July 12, 2016
Medway Planning and Economic Development Board
155 Village Street
Medway, MA 02053

Medway Gardens – Status of Site Plan Implementation

Exelon Expansion Site Plan - Public Hearing Continuation

Photograph 2

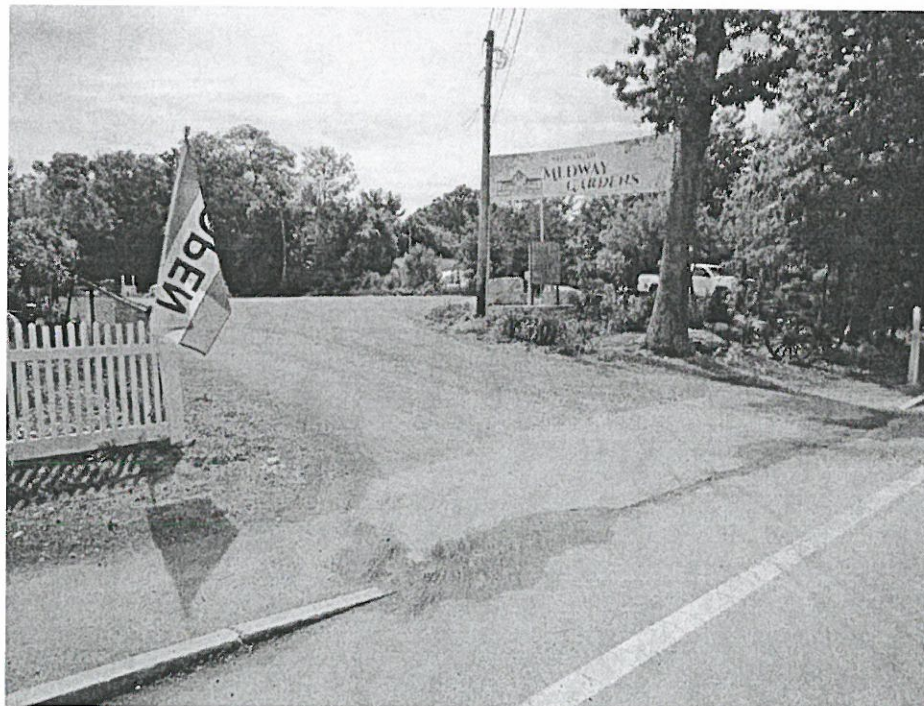
1. Proposed Bituminous Pavement driveway apron and appurtenant railroad ties have not been installed. (See Photo 1-2)
2. Proposed Bituminous Pavement parking area south of the wooden pergola has not yet been installed. (See Photo 3)
3. Proposed Pavement markings and striping (2 coats of paint required) has not yet been installed. (See Photo 4)
4. Proposed Directional and Accessible Signs have not yet been installed. (See Photo 4-5)
5. Proposed Concrete Wheel Stops have not yet been installed in any of the locations shown on the Site Plan. (See Photo 4-5)
6. It appears the Gravel Access drive to Milford Street has not yet been formally installed. An overgrown gravel path exists but it appears it is not what was intended on the Site Plan. (See Photo 5)

Photograph 5

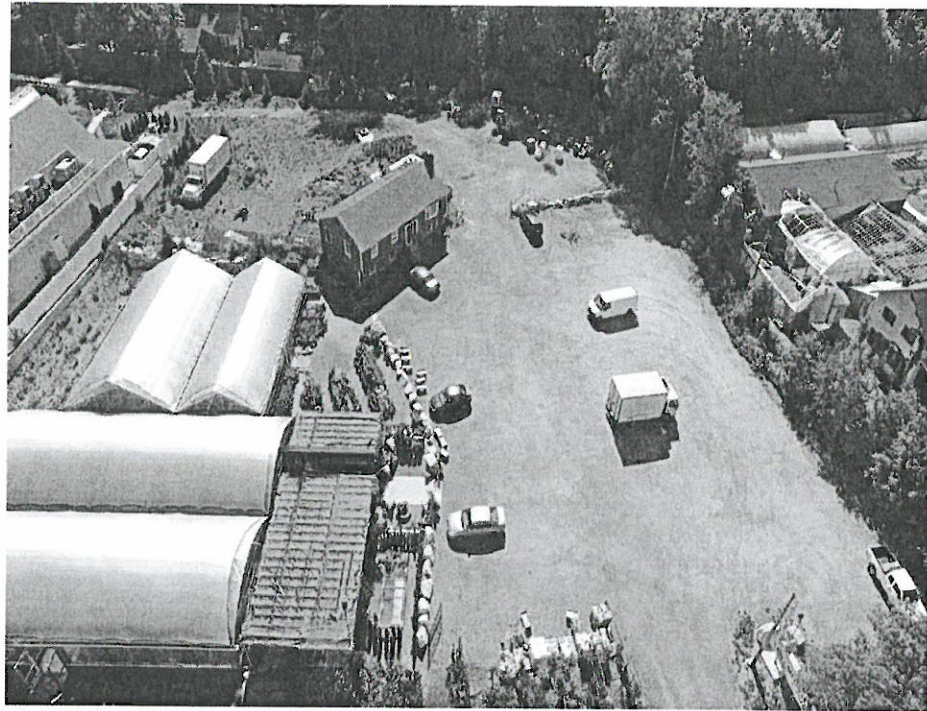
7. The "Medway Garden Center" sign has not yet been relocated with new plantings. (See Photo 5)
8. Evergreen Trees every 20' have not yet been planted along the southern property line. (See Photo 5)

SITE PLAN

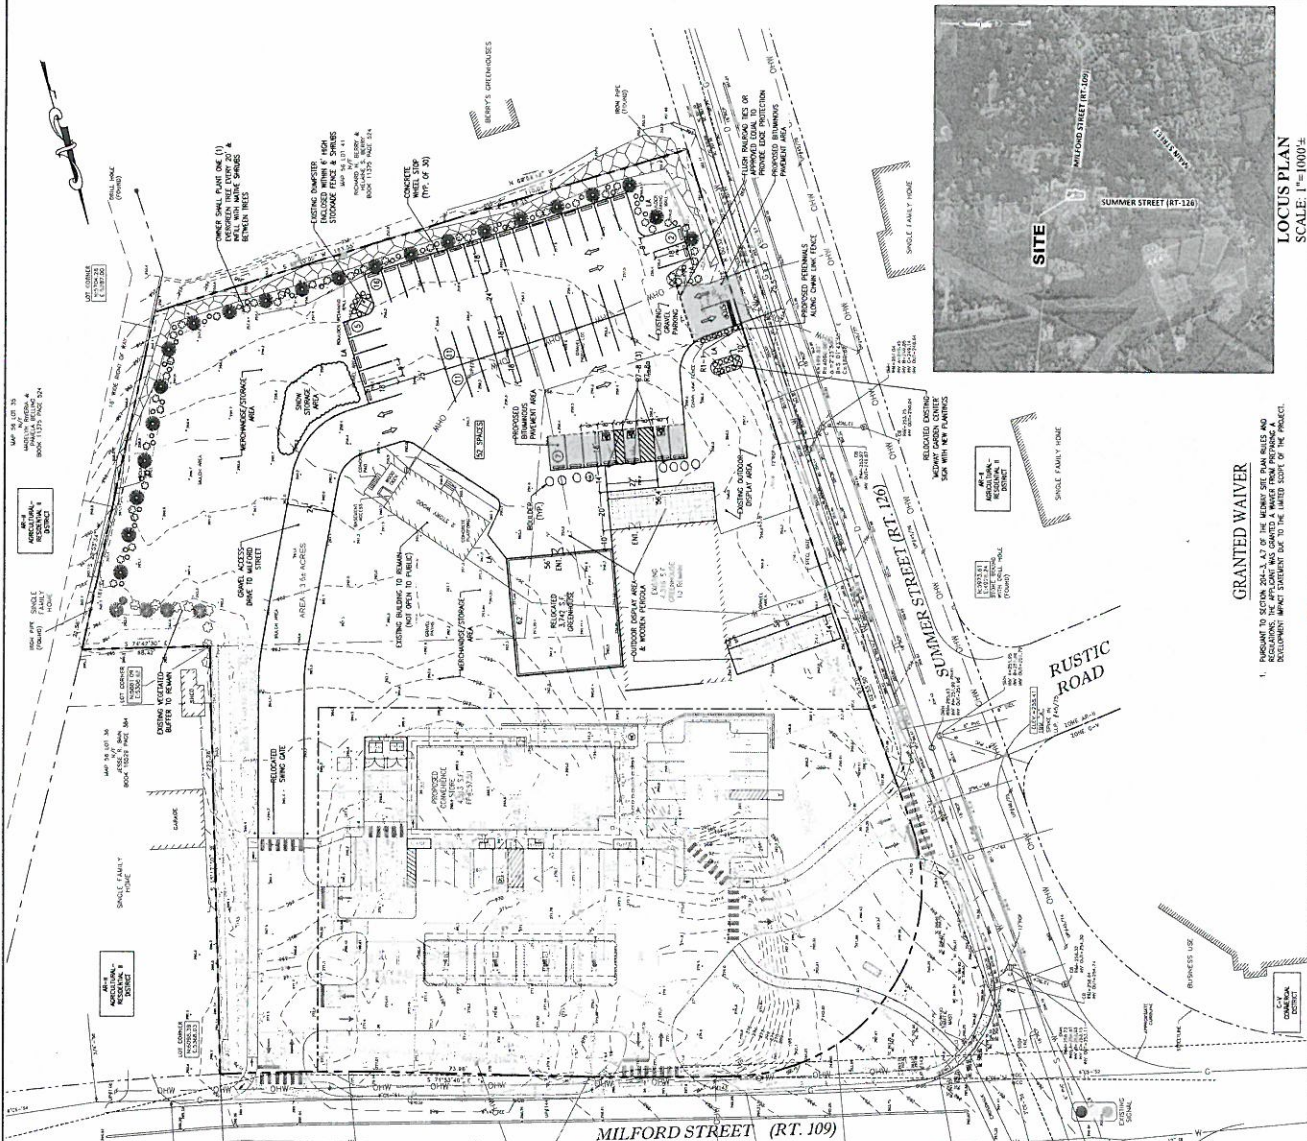
The applicant indicated that the pavement parking to the south will be financially difficult. He would like to seek a waiver to not install this. He communicated that this area is being maintained and has a solid surface for handicap customers.

Consultant Carlucci noted that the plan shows three handicap parking spots and 15 regular parking spots. If there is a variation from this plan, a modification will be needed.

The applicant wants a modification from the markings. Mr. Avellino noted that the striping will not be done as the paving is gravel and it just doesn't work.

The applicant agreed to provide a new set of plans by September 1, 2016.

The Board is in agreement that the applicant will need to seek a plan modification. The modification deadline will be September 1, 2016 for the application to be submitted.
